A joint committee with members representing AIBC, EGBC, BOABC

File No: 18-0020 INTERPRETATION Page 1 of 6

June 26, 2019
BC Building Code 2018
Building Service Penetrations at Contiguous Stairs
Contiguous, stairs, service penetrations
3.4.4.4.(2) & (3), A-3.2.6.2.(2)

Drawing #3 - Below Grade Exit Stair Beneath an Above Grade Exit Stair With a Shared Exit Corridor

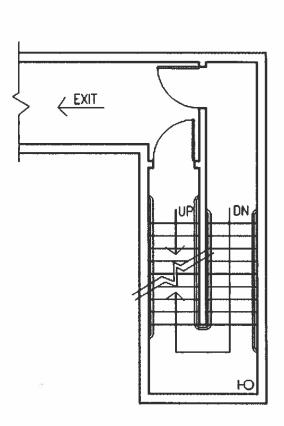
This project includes a below grade stair that discharges directly outside at Level 1. There is an above grade stair where its stair enclosure is directly above the below grade stair. The above grade stair also discharges directly outside at Level 1 via a shared exit corridor. Refer to Drawing #3 & #4 on Pages 5 & 6.

- 1. Does the ceiling assembly of the below grade stair at Level 1, which also acts as the floor assembly of the above grade stair create a "contiguous stair" between the above and below grade stairs?
- 2. Can a standpipe riser penetrate the ceiling assembly of the below grade stair at Level 1, which also acts as the floor assembly of the above grade stair?

Drawing #3 – plan of below grade exit stair beneath an above grade exit stair with a shared exit corridor serving both exit stairs.

This configuration is not considered to be contiguous stairs for the purposes of Article 3.4.4.4.

1. No

Although the term "contiguous stair" is not a defined term in the building code, it is generally considered to be either 2 scissor stairs or 2 side by side stairs with a common wall for the full height of the stair enclosures as illustrated on Pages 3 & 4. Also, 2 contiguous stairs generally serve the same floor area, so penetrations between the 2 exit stairs would compromise both means of egress from a floor area.

2. Yes

Sentence 3.4.4.4.(2) requires that exits within scissor stairs and other contiguous stairs be separated from each other with a smoke-tight fire separation with a fire resistance rating not less than that required for the floor assembly through which they pass.

Sentence 3.4.4.4.(3) prohibits penetrations through floor or wall assemblies that separate scissor stairs and other contiguous stairs such as doorways, ductwork or piping. Since the above and below grade stairs are not considered to be "contiguous stairs", the requirements of Sentence 3.4.4.4.(3) do not apply.

Drawing #4 - Below Grade Exit Stair Beneath an Above Grade Exit Stair With a Shared Exit Corridor

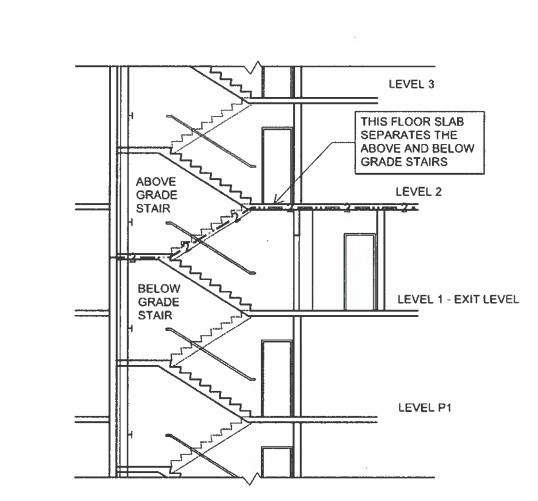
Drawing #4 – section of below grade exit stair beneath an above grade exit stair.

This configuration is not considered to be contiguous stairs for the purposes of Article 3.4.4.4.
